REQUEST FOR INFORMATION	DATE: December 16, 2016	NO.: RFI-385
--------------------------------	--------------------------------	---------------------

Project Name: 15051-Webster University Interdisciplinary Science Building	Project No.: 15051
---	--------------------

Subject: Curtainwall fin termination at composite metal panels

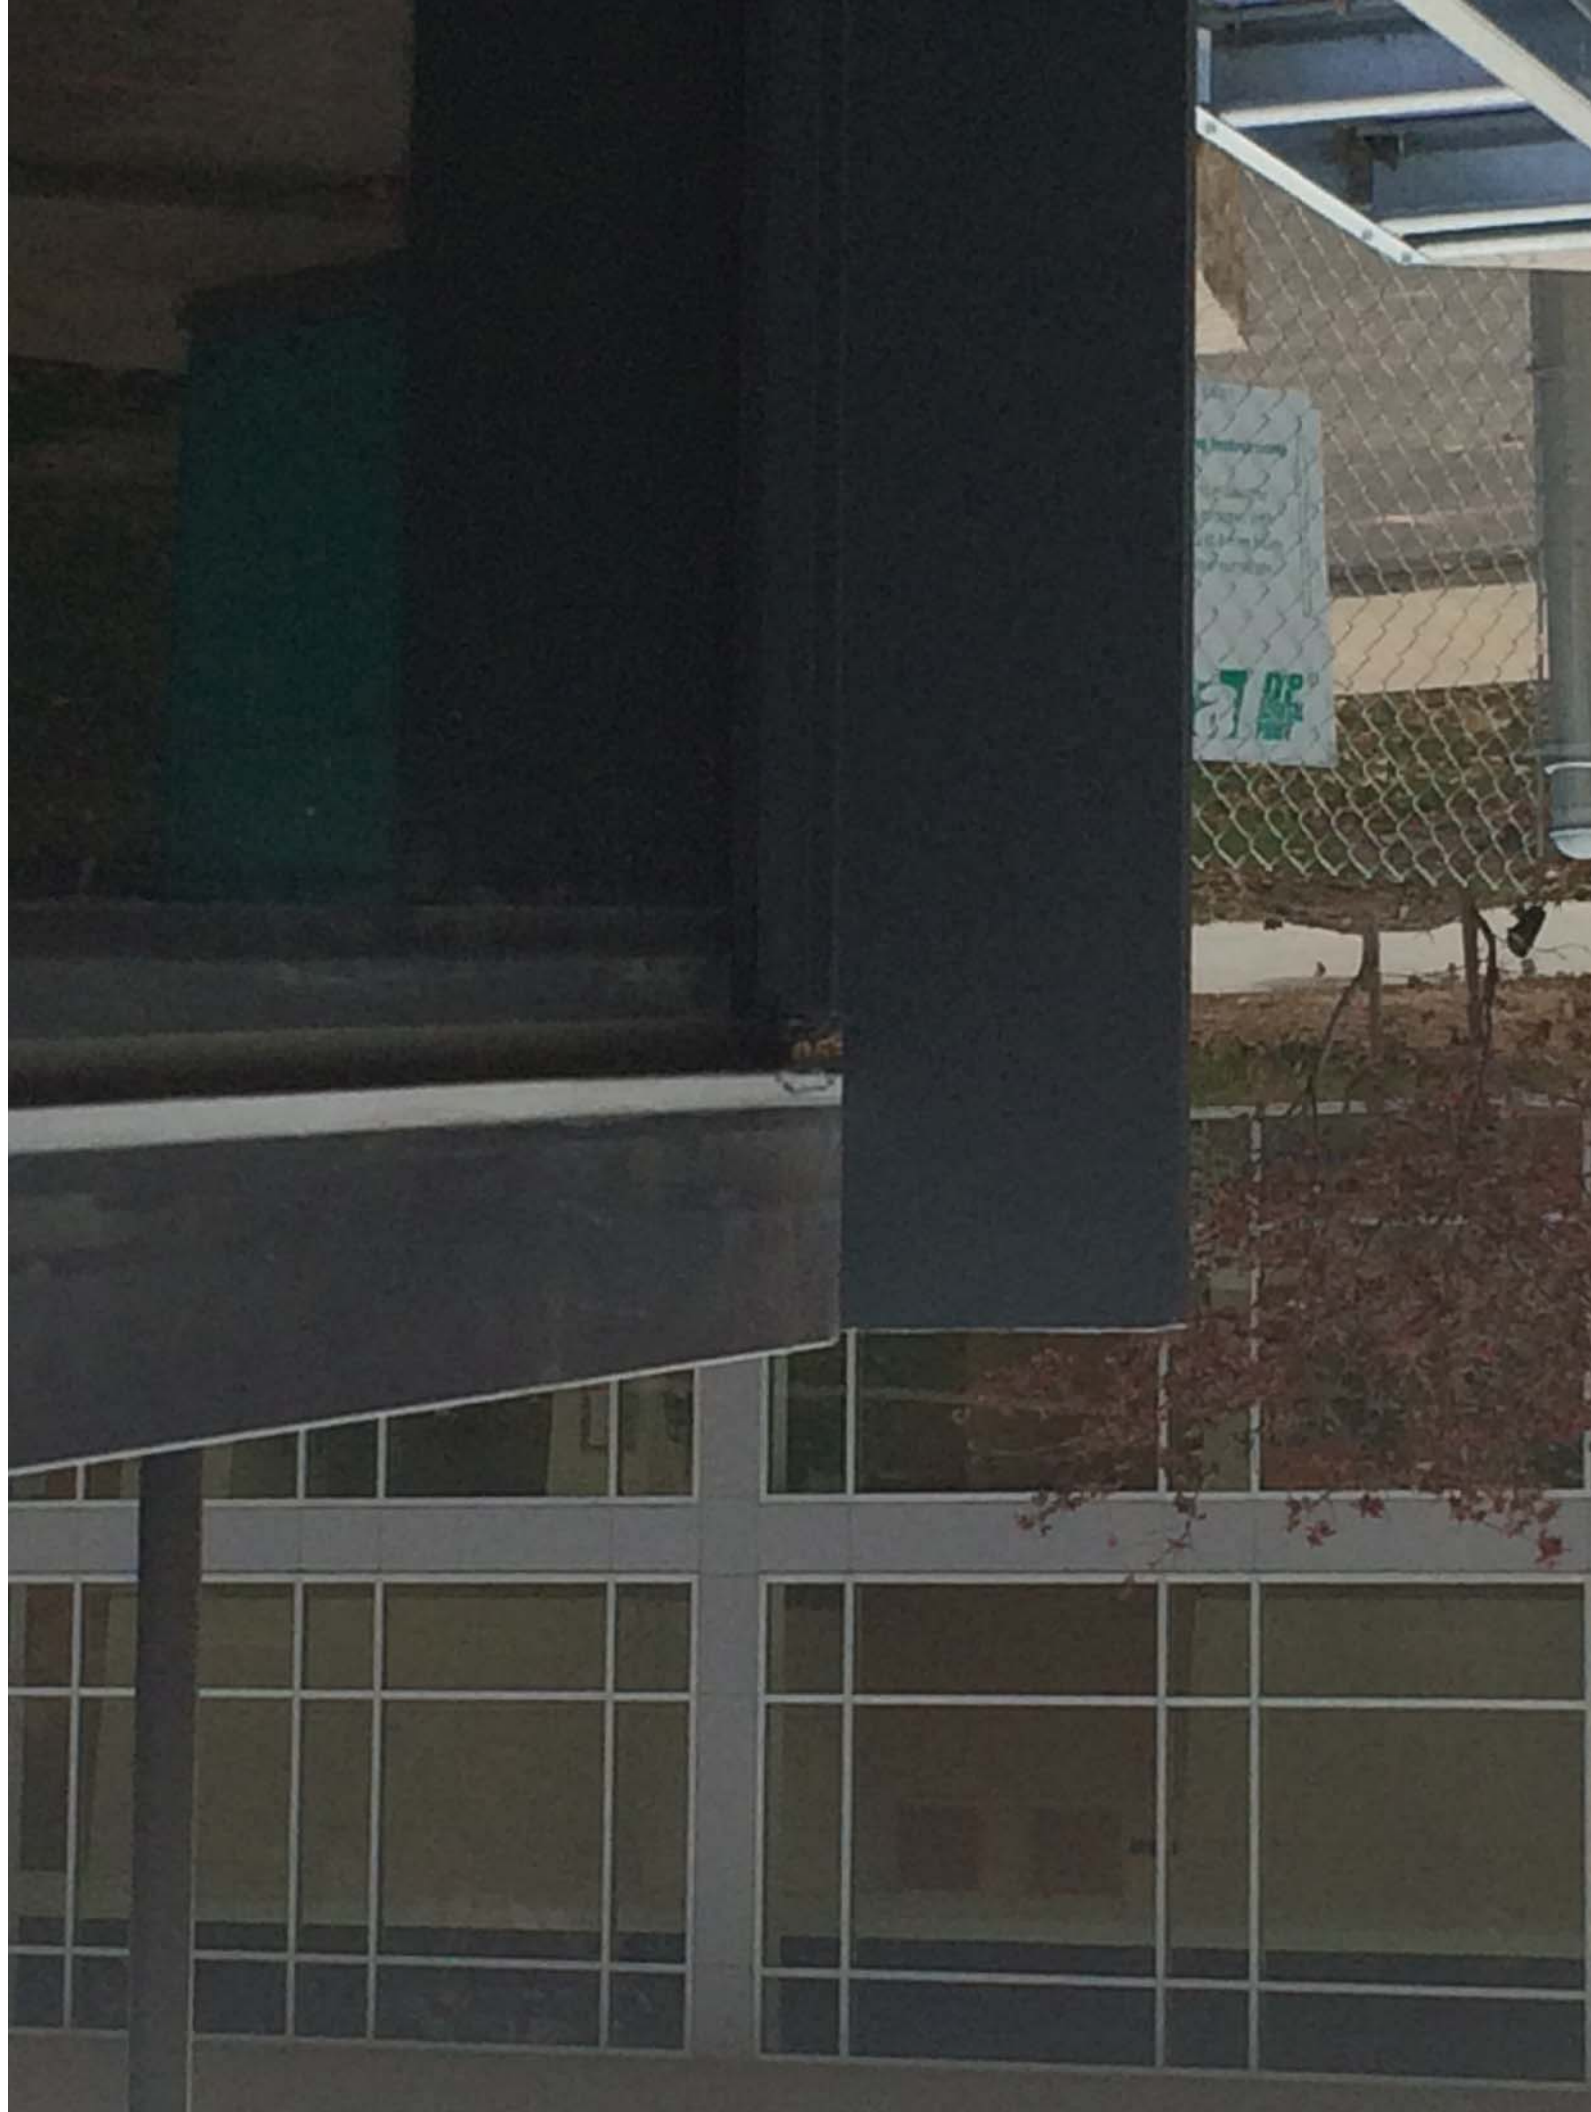
This is a confirming RFI that the "receiver" for the curtainwall fin will terminate at the bottom of the composite metal panel coping cap per the attached drawing markup. The fin will be notched and terminate at the top of the cap similar to detail 7A451.

It is acceptable for the "receiver" of the curtainwall fin to be terminated at the bottom of the composite metal panel coping cap similar to detail 7/A0451. Contractor shall provide documentation to show how the curtainwall fins will be capped at the top. Sealant will not be acceptable.

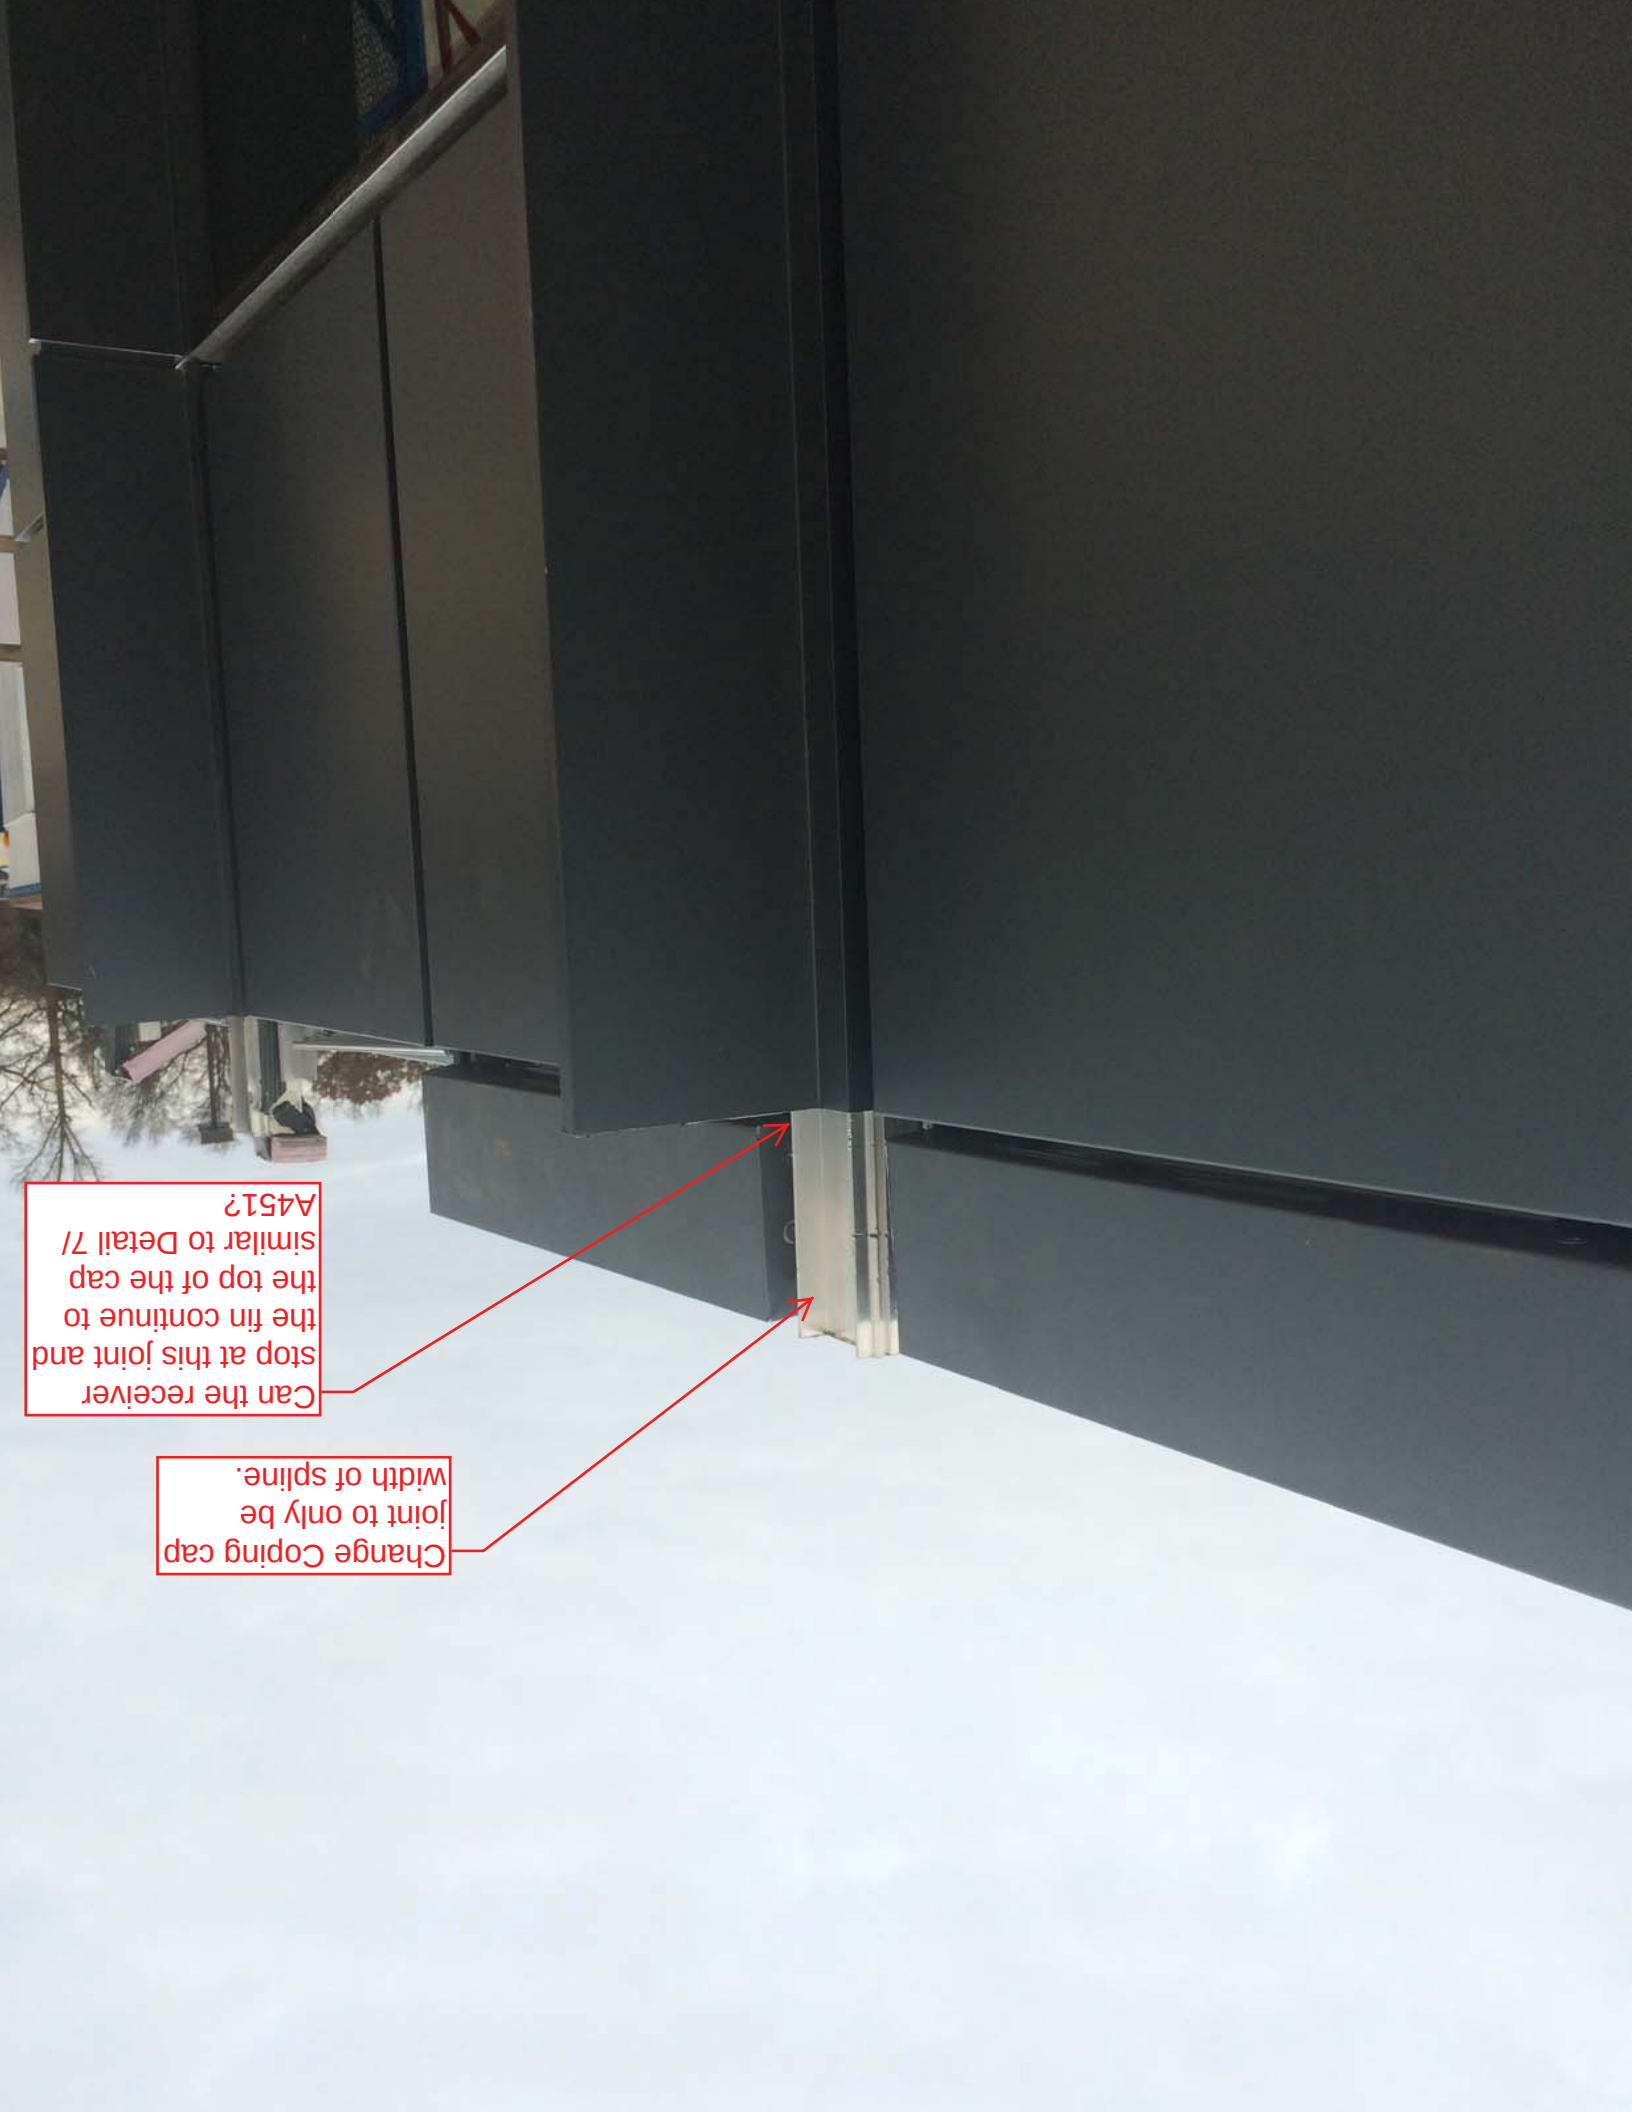
Can the receiver
stop at this joint and
the fin continue to
the top of the cap
similar to Detail 7/
A451?

Change Coping cap
joint to only be
width of spline.

Top of Fin to
continue to top of
parapet without
receiver similar to
curtainwall detail

Sky joint to be
centered on fin
